RE: 17TH STREET CANAL PARALLEL FLOOD PROTECTION
PHASE 1B - HAMMOND HIGHWAY TO SOUTHERN RAILWAY
OLB PROJECT NO. 2043-0207

In your letter of October 21, 1988, you listed comments on our preliminary plans for the above referenced project. In our review of those comments, we discovered that the slope stability calculations for the first six reaches of this project do not properly reflect the actual factors of safety.

We are submitting revised slope stability and sheet pile analyses for Reaches 1 through 6 which supersede the previously submitted calculations and consequently make obsolete comments "a" and "b" of your letter of October 21, 1988.

REACH 2
STA. 568+00 TO STA. 589+00

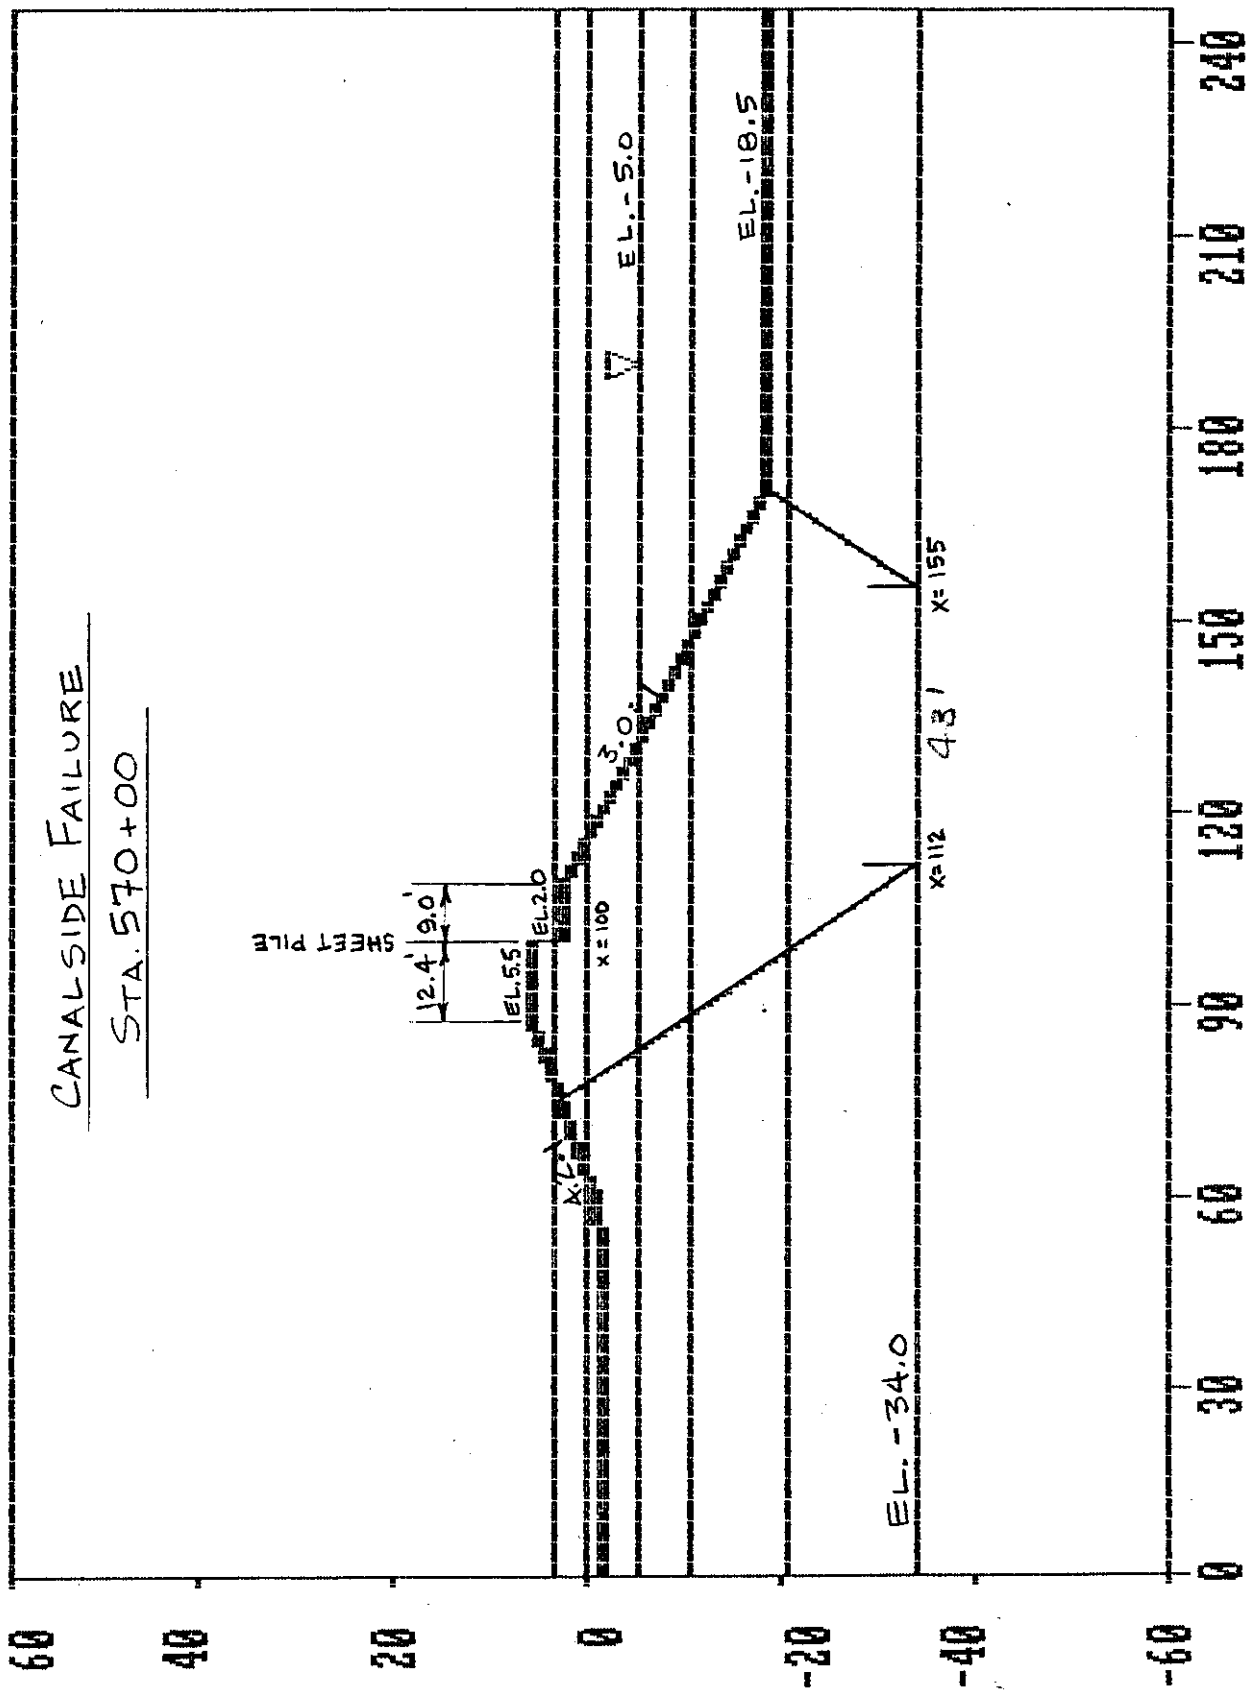
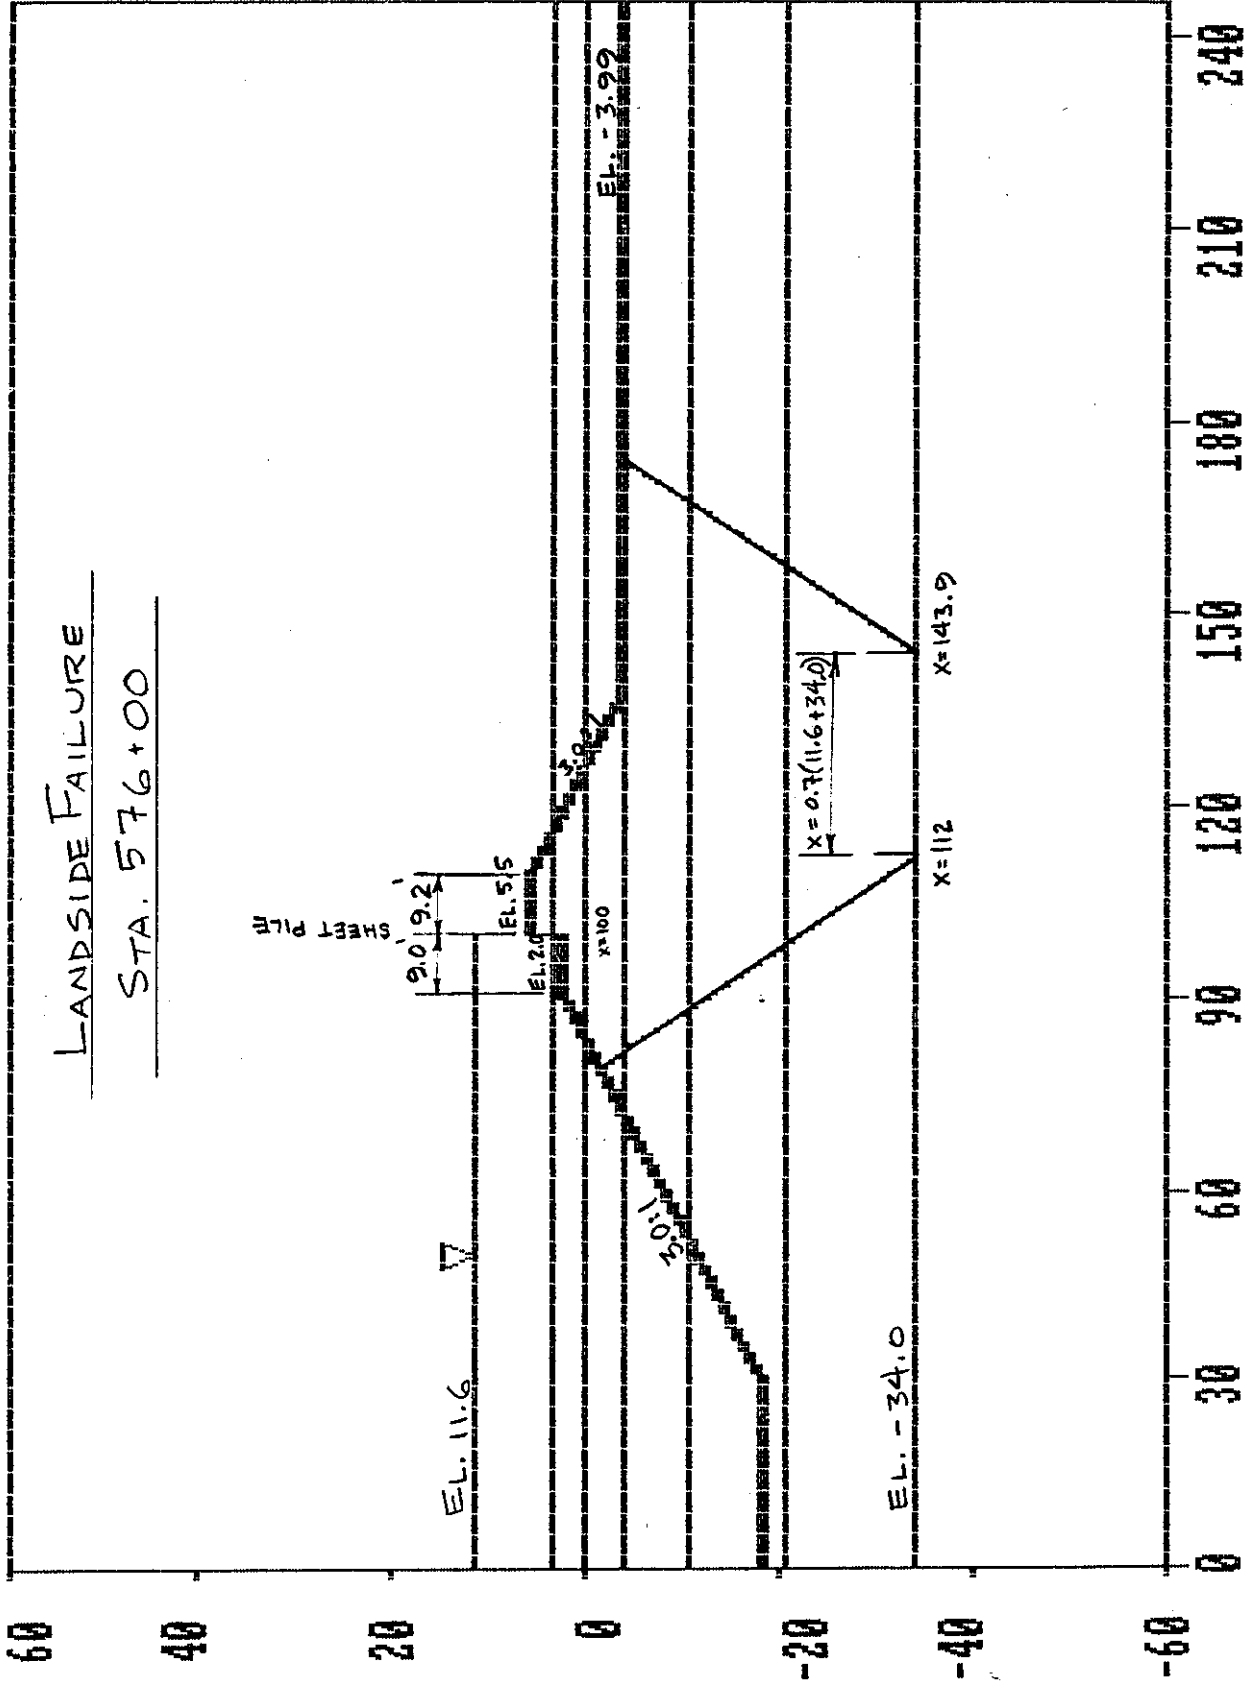
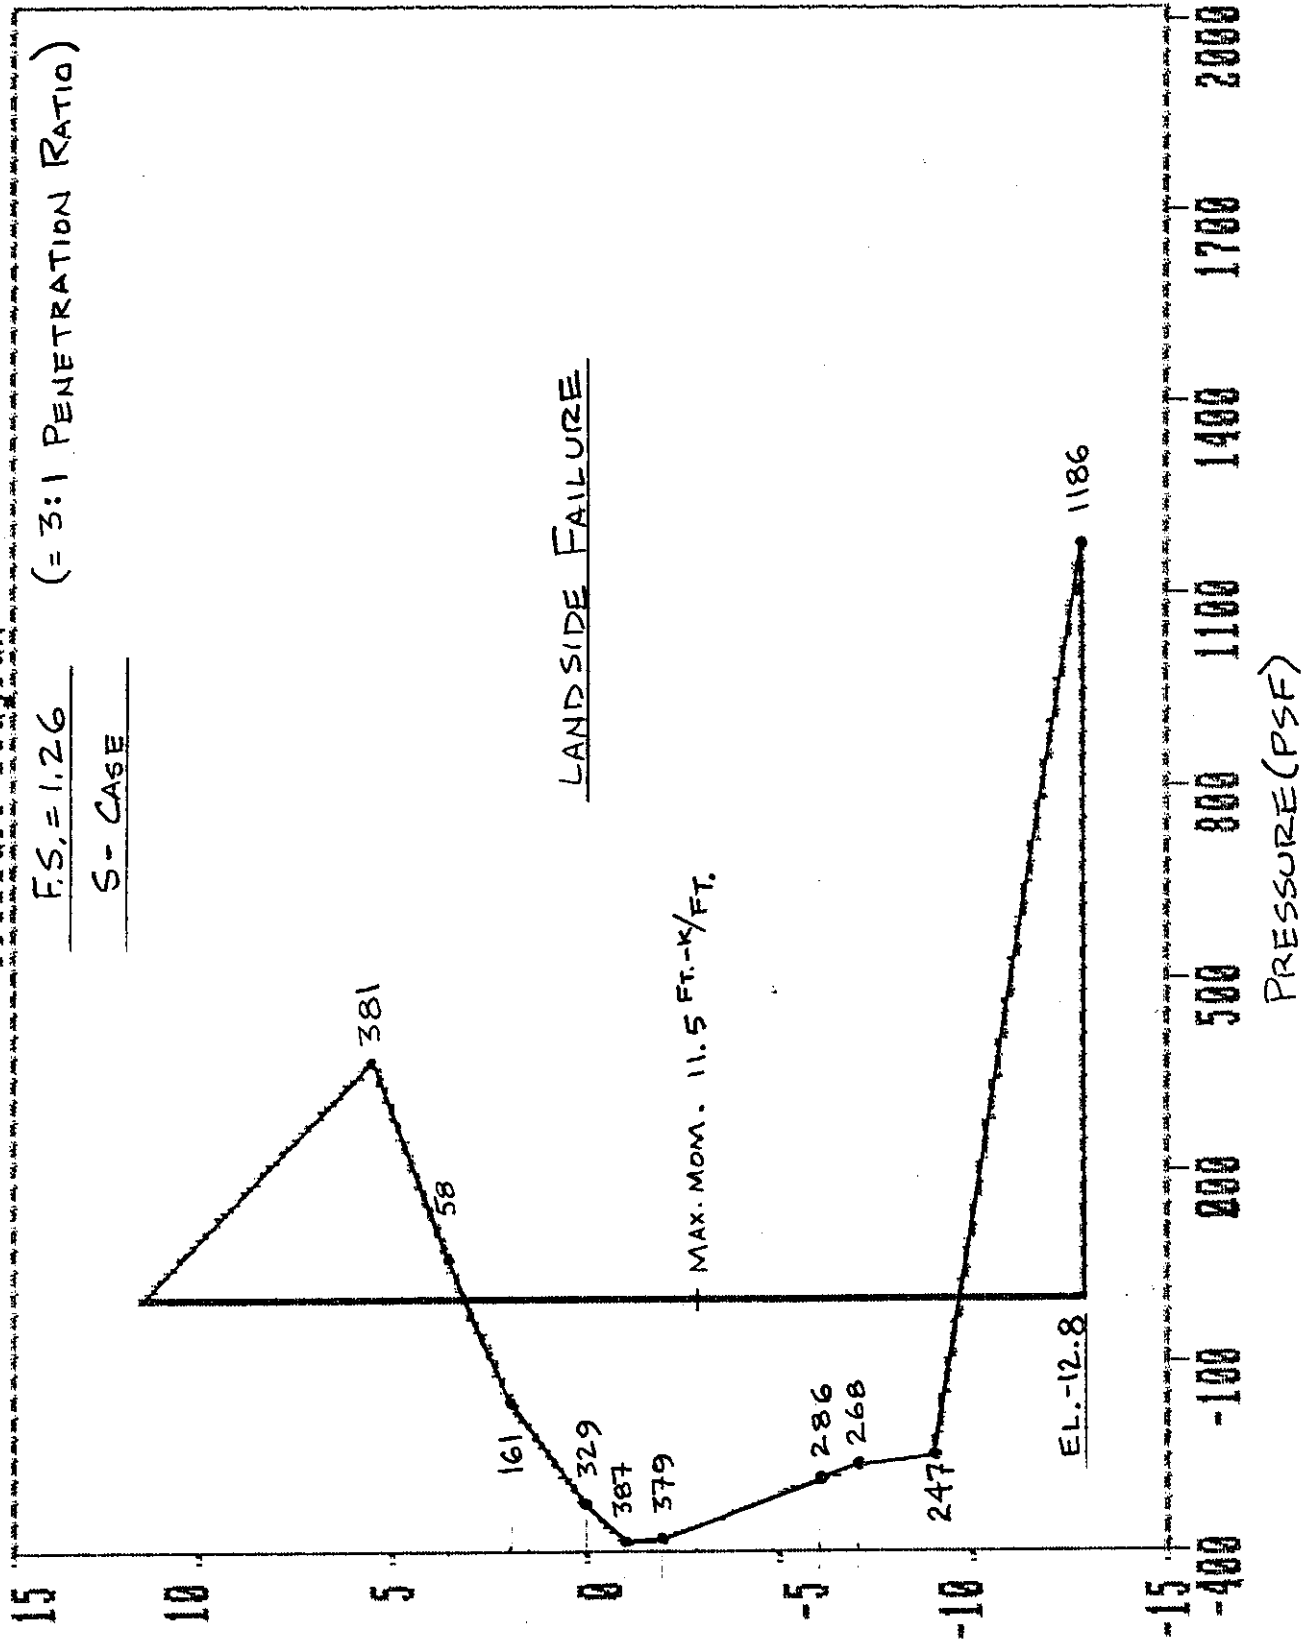
Revisions to Cross-Section : Realign Sheet Pile
Decrease Step Width to 9.0' (Hold Elevation at 2.0)

GDM section - 12.74 (F.S. = 1.32) (3:1) with 9' I-Wall
Bench @ +2.5 Max Crown width 13' crown

Canalside Failure - 570+00.
*** Minimum Factor of Safety = 1.31 ***

Landside Failure - 576+00, 578+00, 584+00 and 588+00. The section at Sta. 576+00 governs.
*** Minimum Factor of Safety = 1.33 ***

Required Penetration : -12.8 (Landside Failure 3:1 Ratio; S-Case F.S. = 1.26)
Design Bending Moment : 11.5 Ft-K/Ft @ El. -2.7 (Landside Failure 3:1 Ratio; S-Case F.S. = 1.26)
Maximum Deflection : In.
